STAFF REPORT SUMMARY

To: Edgerton Planning Commission
Fr: Kenneth Cook, AICP, CFM, Community Development Director
Re: FP2016-04, Final Plat for Midwest Gateway, located on the North side of 191st Street and 1,500 feet West of Kill Creek Road.

To: Edgerton Planning Commission
Fr: Kenneth Cook, AICP, CFM, Community Development Director
Re: FS2016-10, Final Site Plan for Midwest Gateway, located on the North side of 191st Street and 1,500 feet West of Kill Creek Road.

Final Site Plan Application No. FS2016-10
Final Site Plans Midwest Gateway

SHEET NUMBER
3 OF 13
LANDSCAPE PLAN

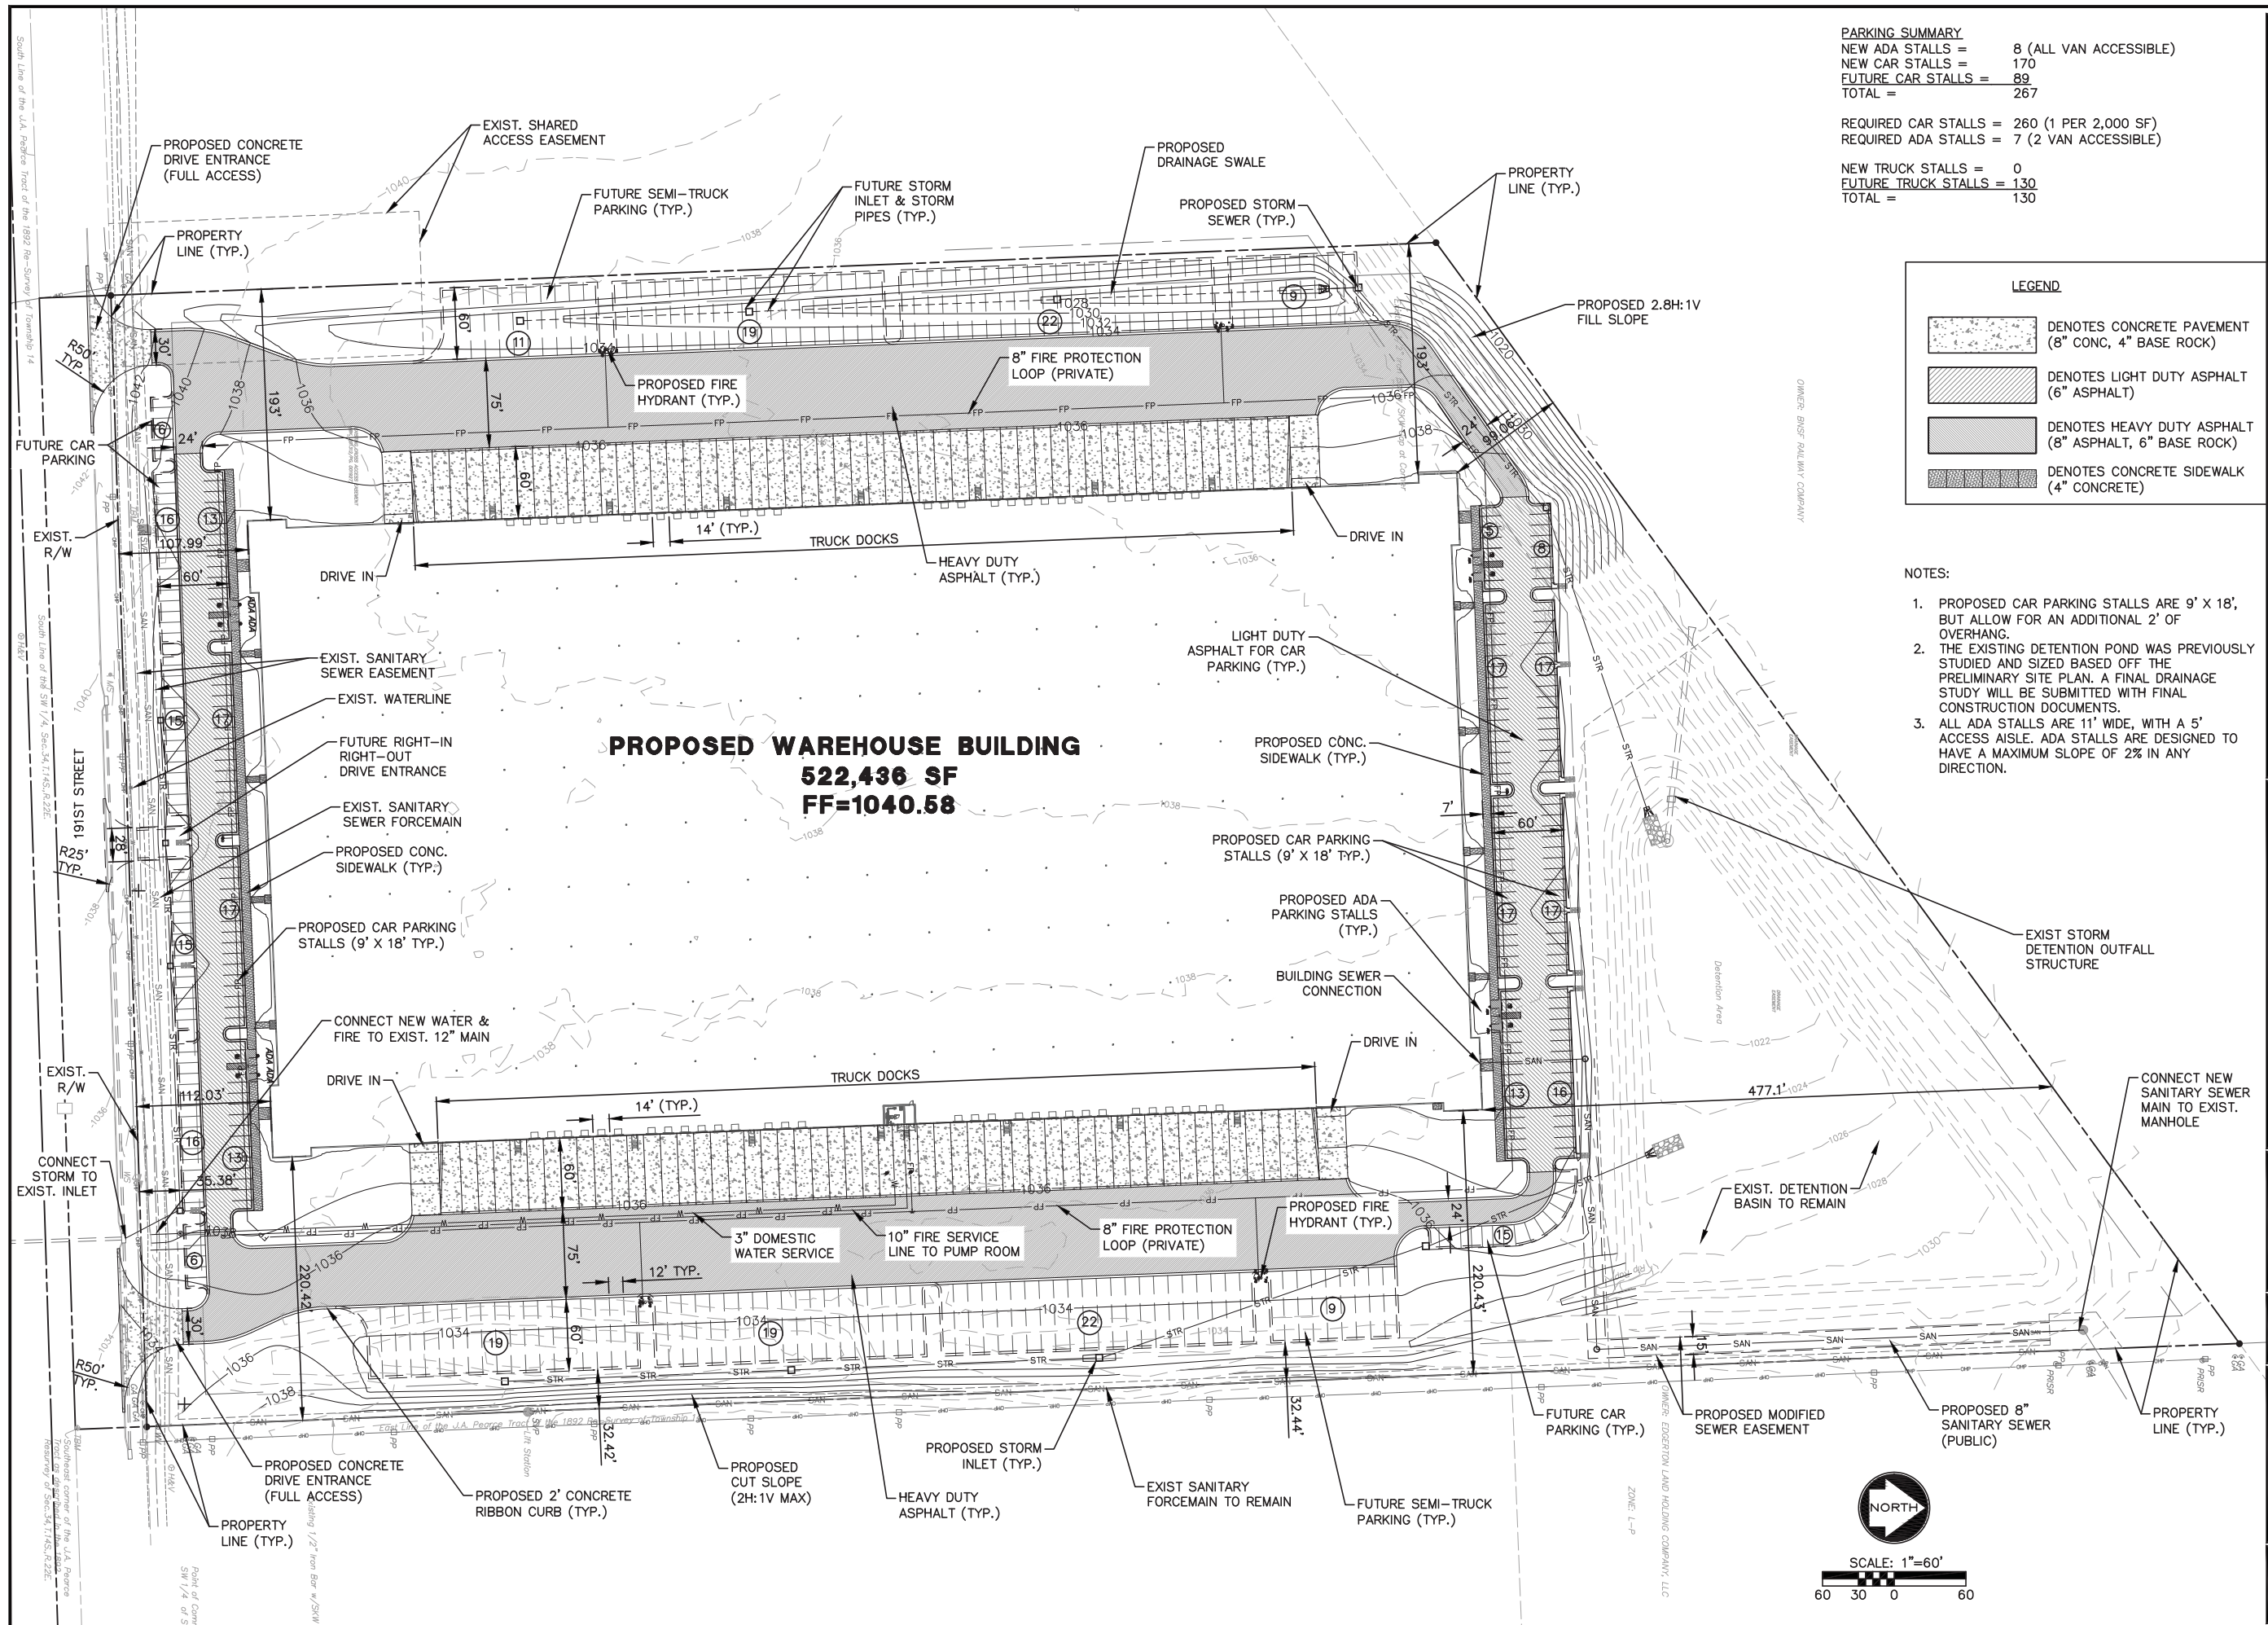
- *Trash containers and screening have not been shown.*
 - *Please indicate right-of-way for 191st Street on landscape plan sheets.*
 - *No shrubs, landscaping in parking areas or adjacent to the building have been provided*

- *To the landscaping notes, please add text that states the proposed landscaping shall be installed so that when at full maturity it will not encroach into identified sight triangles.*

- *No timetable has been indicated for any of the planting.*
 - *Please verify quantities on both landscaping plans as the quantities listed does not match those depicted. Missing 3 Eastern Red Cedar Trees.*

*In general, the landscape plans that have been submitted to not comply with the standards of the L-P District. No hedge or shrubs have been provided anywhere on the site and no landscaping is shown in parking areas or adjacent to the building. The location of dumpsters have not been shown and will require screening. The standards also specify that "all fencing visible from a public ROW shall be either masonry of a type and style complementary to the primary materials of the building, wrought iron, decorative metal, living plant material or a combination of these." Staff recommends that the fencing along the front of the property needs to be upgraded to meet these requirements. Fencing along the sides will also need to be upgraded to a point where they are not considered "visible" from the public ROW. Please review the Landscape standards listed in section 5.2 O. of the UDC. **Update Landscaping and Final Site Plan.***

EXTERIOR ELEVATIONS

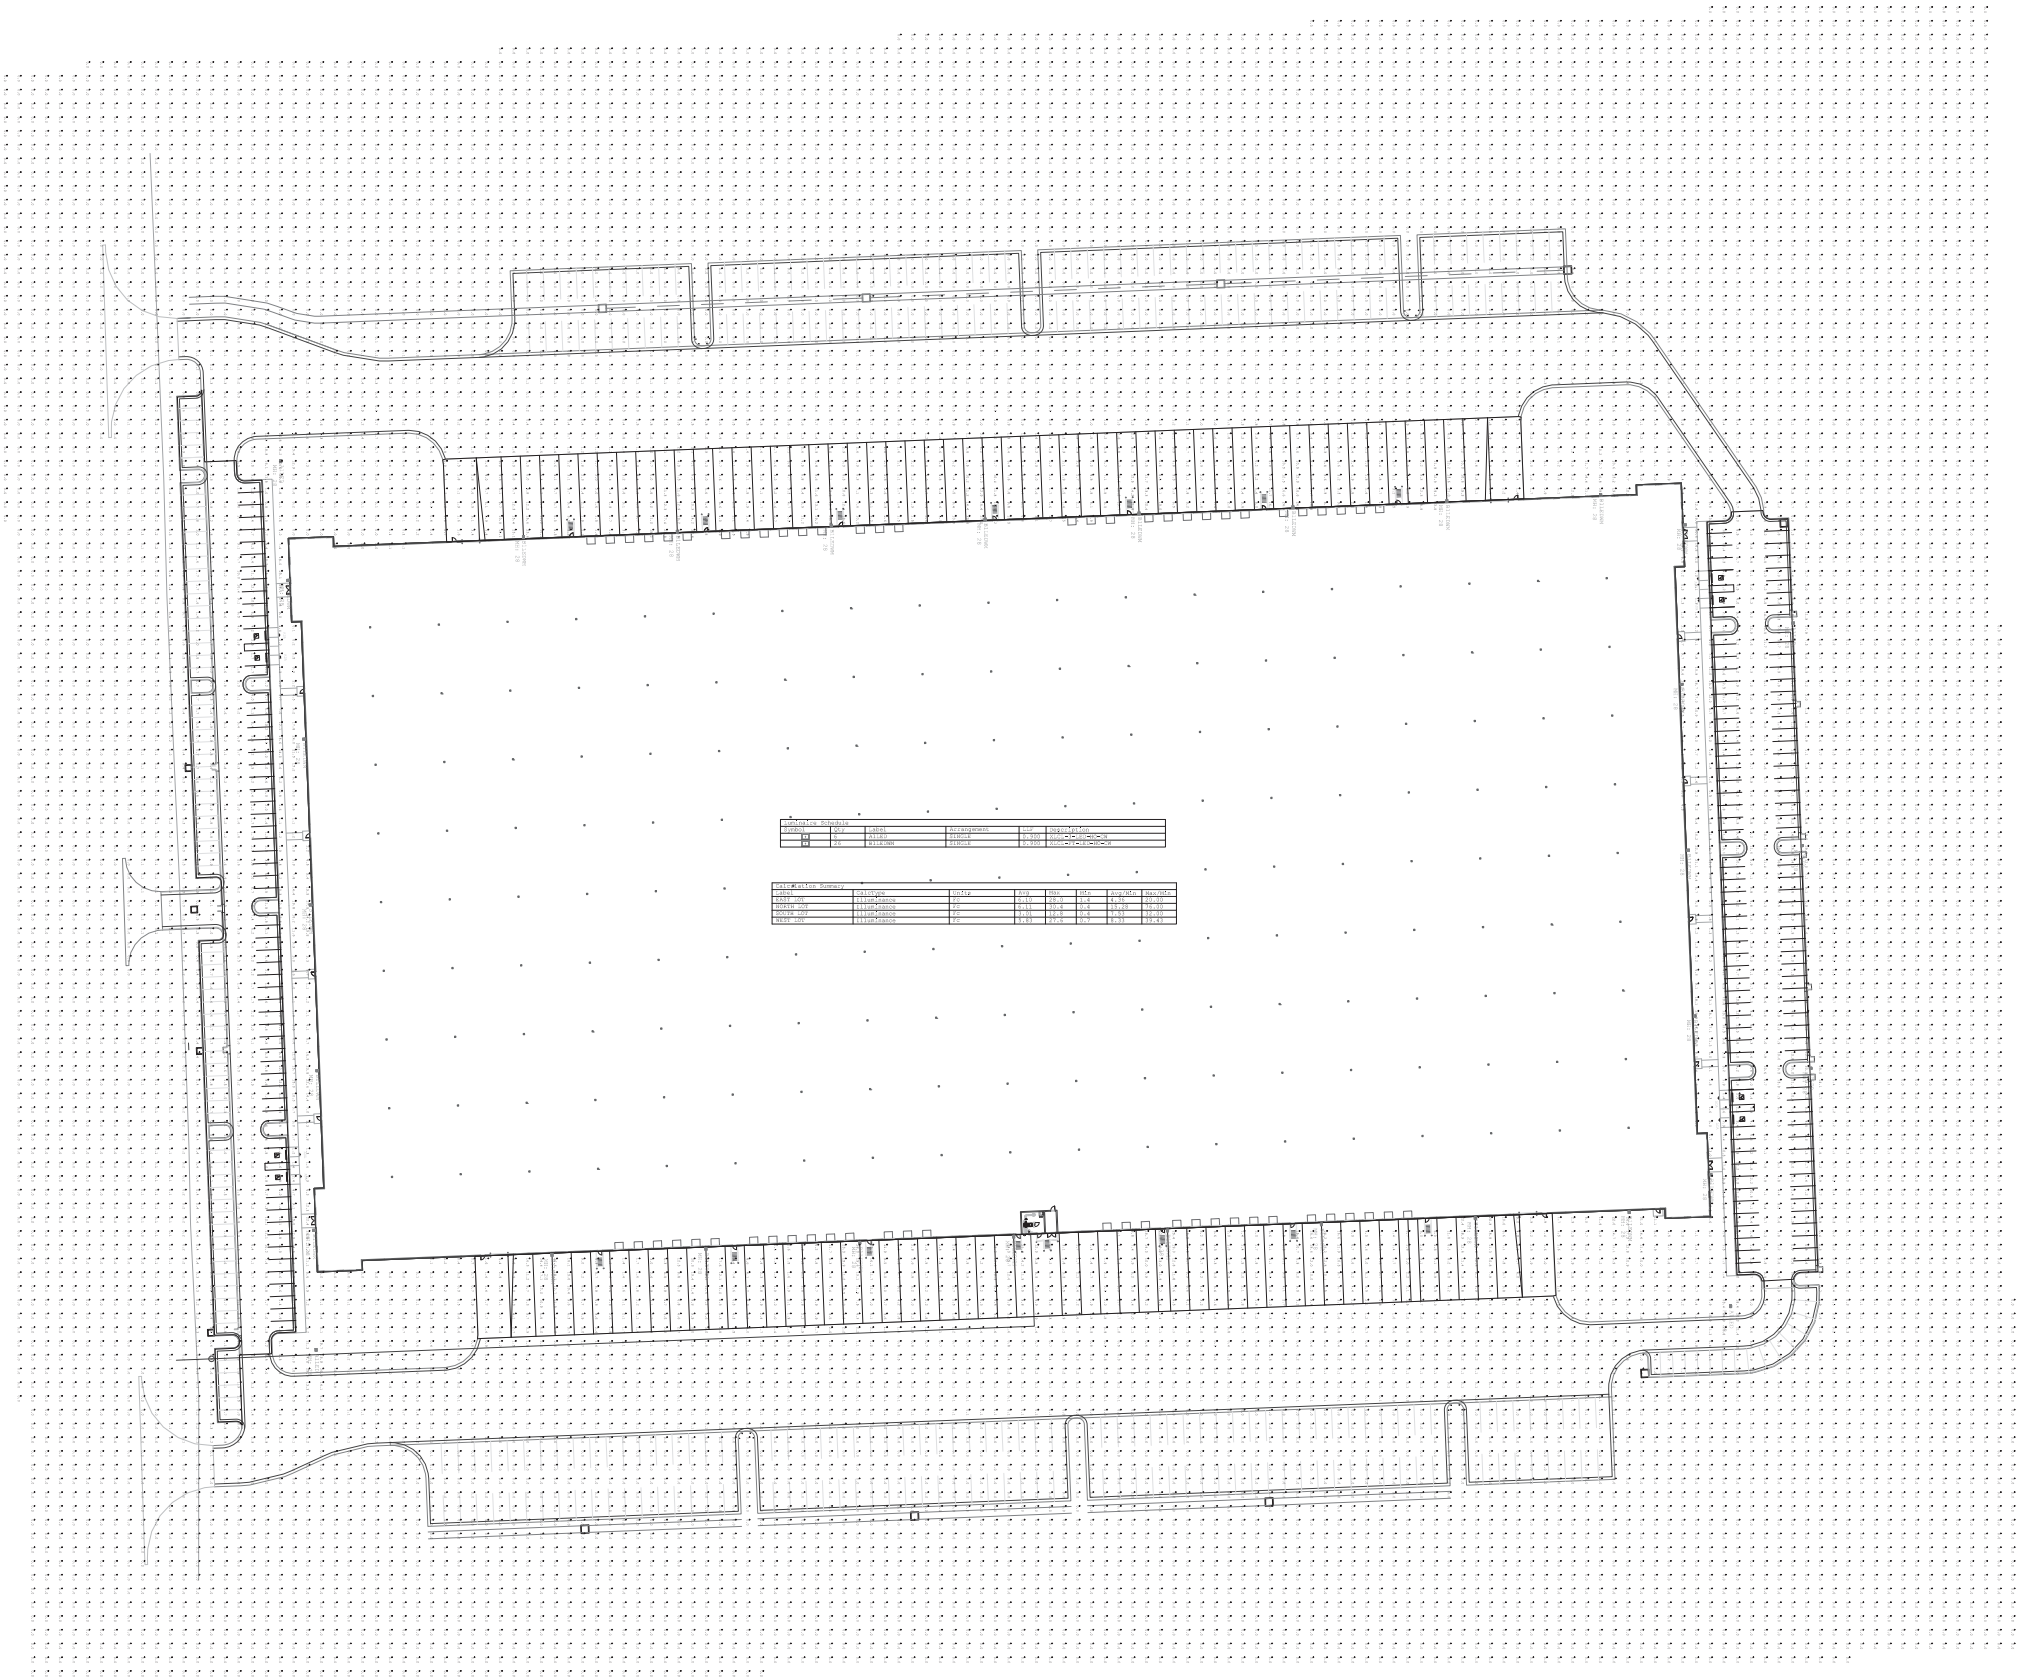
*proposed building elevations. The South wall of the structure contains a parapet that extends above the roof and could provide some screening of equipment. Staff is concerned that rooftop equipment will still be visible as the side walls do not include parapets and any equipment placed in on the roof would possibly be visible from 191st Street. If rooftop equipment visible from the ground and street level is planned, parapets to conceal it from the ground and the streets shall be required prior to building permit approval. **Determine if any equipment will be screened from public view.***
